SUBDIVISION REVIEW SHEET

CASE NO.: C8-2020-0033

SUBDIVISION NAME: Saddle Ridge at Wildhorse Ranch Preliminary Plan

CITY OF AUSTIN –DEVELOPMENT SERVICES DEPARTMENT
SUBDIVISION APPLICATION – MASTER COMMENT REPORT

COVER SHEET

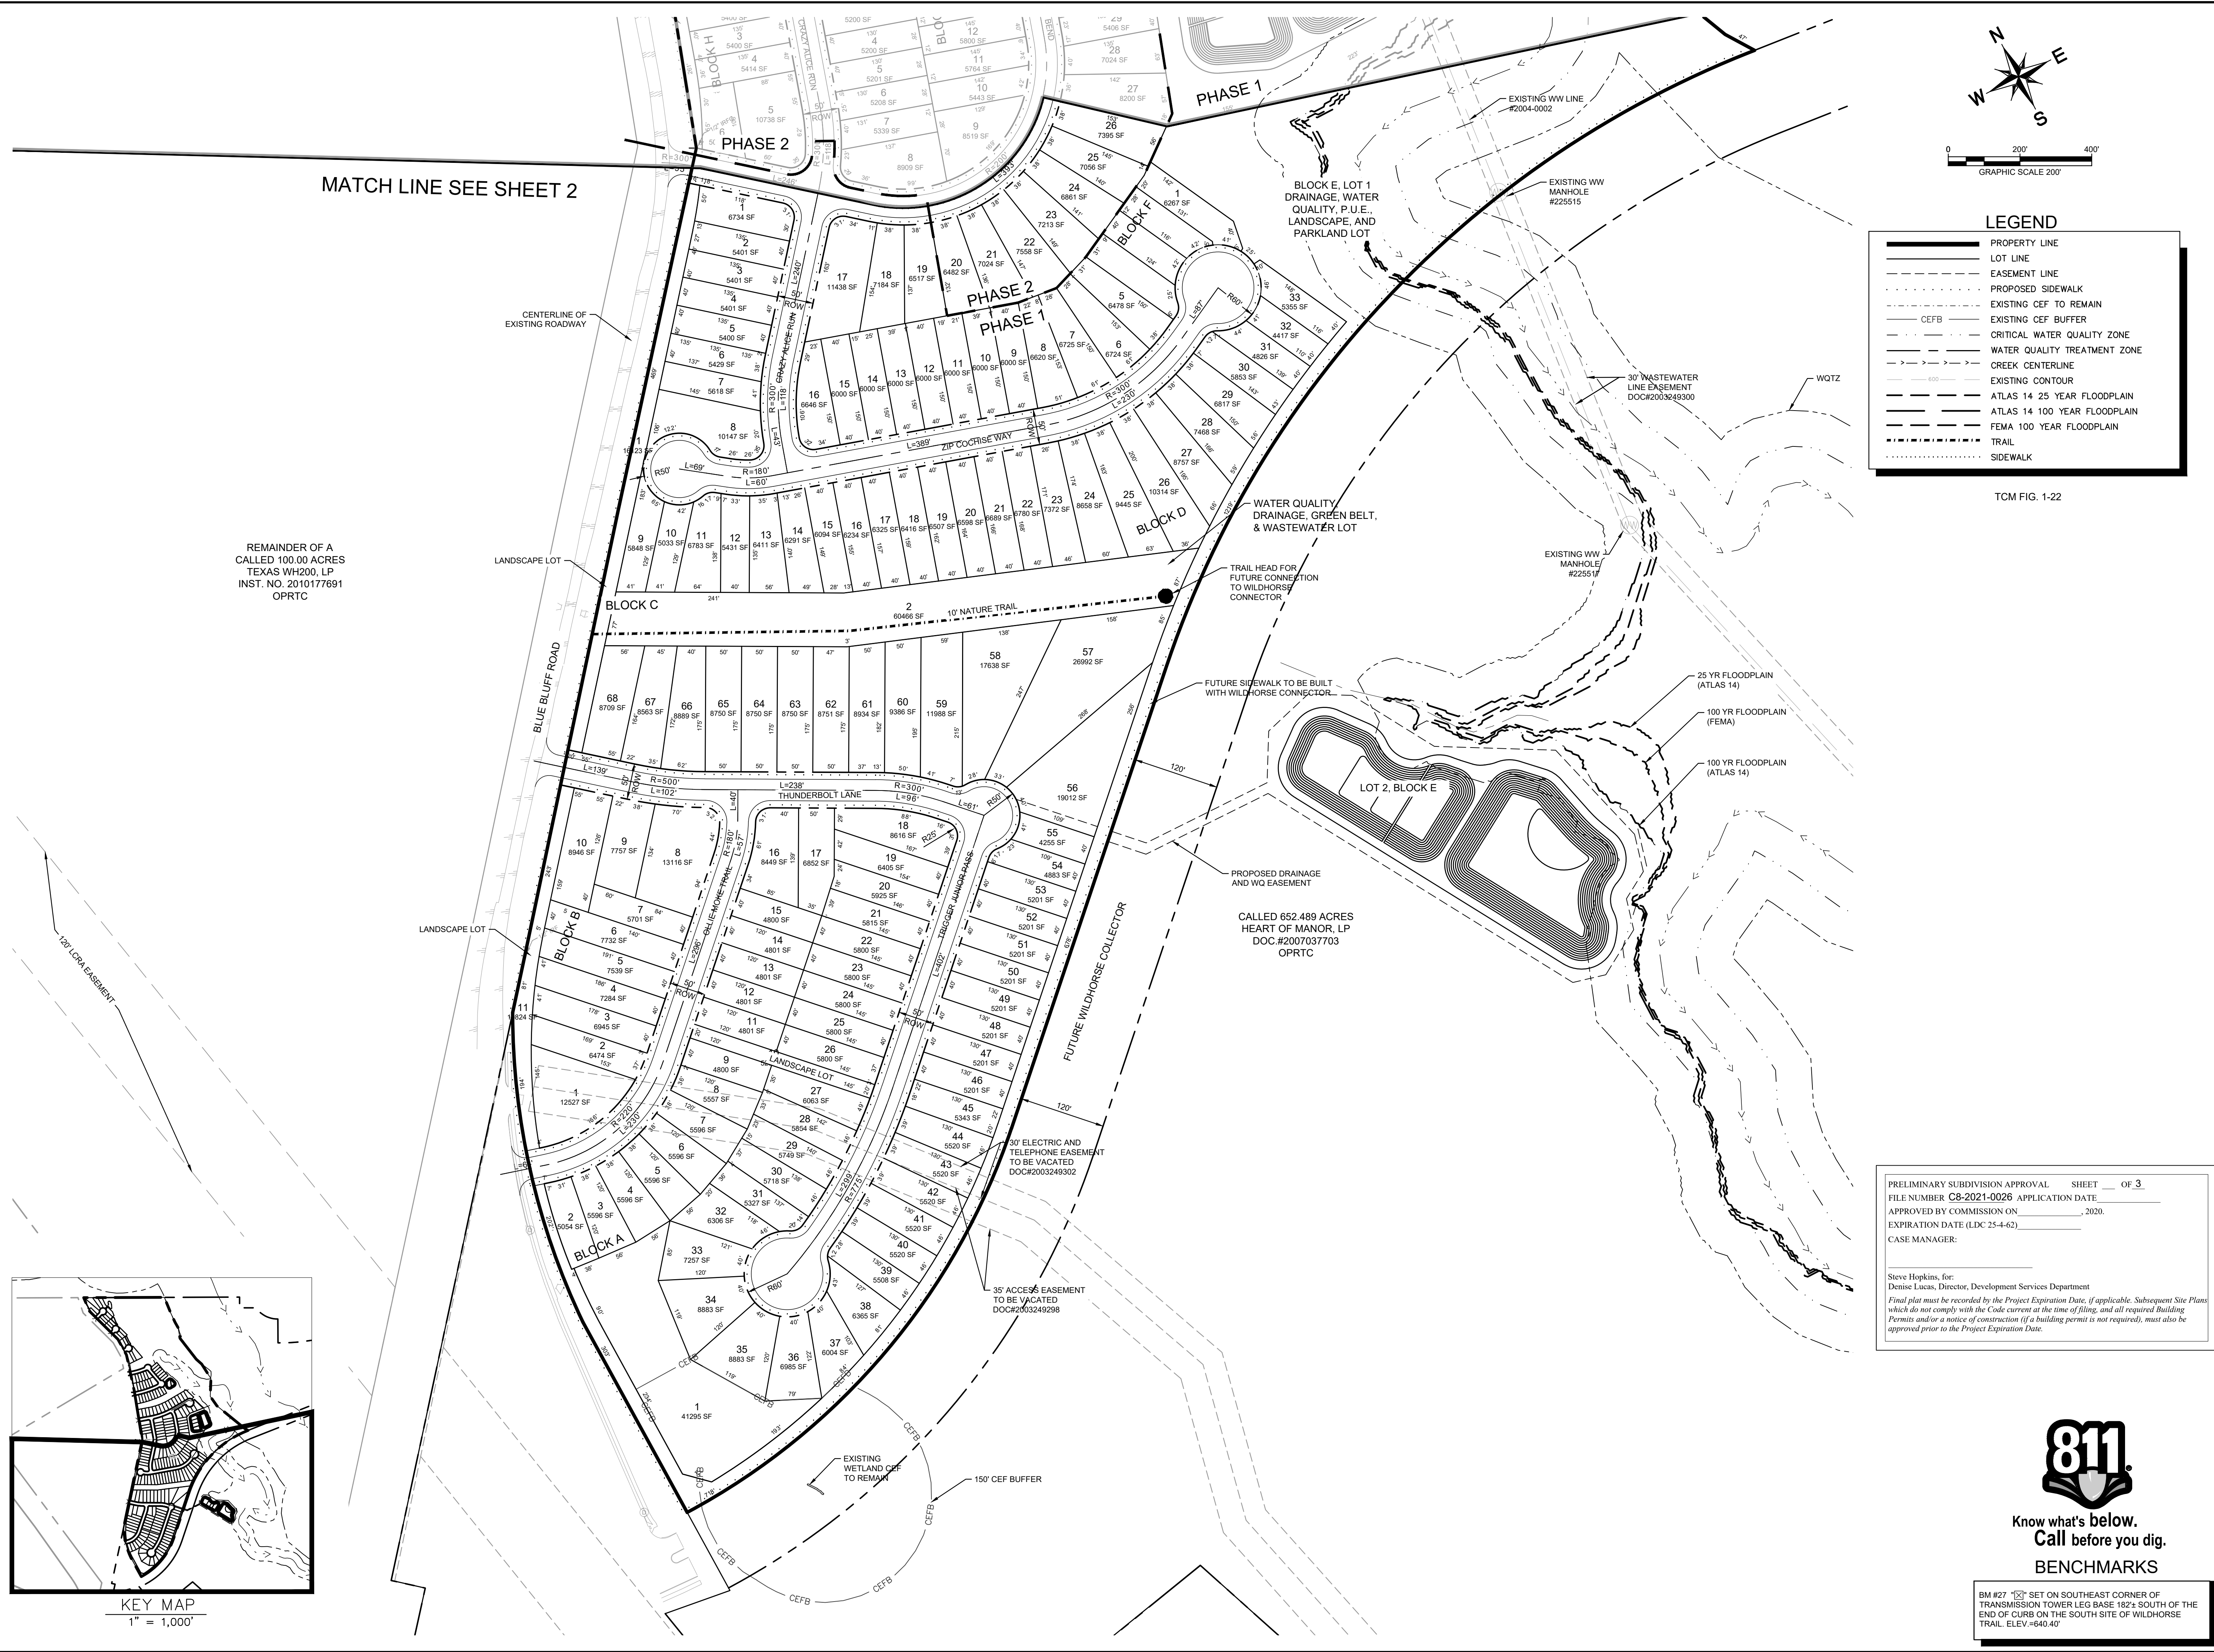
SR 3: Revise note 20 as follows (LDC § 25-1-83):

“Prior to the recording of any final plat of all or a portion of this preliminary plan, fiscal security shall be provided in accordance with LDC §25-1-112 of the Land Development Code for the following subdivision improvements:

- (A) Street construction and related infrastructure, including paving, drainage, sidewalks, water supply and wastewater collection, for the following streets:

List all internal streets, and Blue Bluff Road.

Fiscal security is not required for streets not listed in subsection (A).

- (B) Environmental and safety controls, and other related items (e.g., erosion and sedimentation controls, restoration, channel work, pipe in easements, detention, water quality ponds, etc.) as determined prior to final plat approval. The restoration cost estimate will be based on disturbed areas including the following streets:

List all internal streets, and Blue Bluff Road.”

UPDATE 1: Streets are still not listed in part (B). Please update.
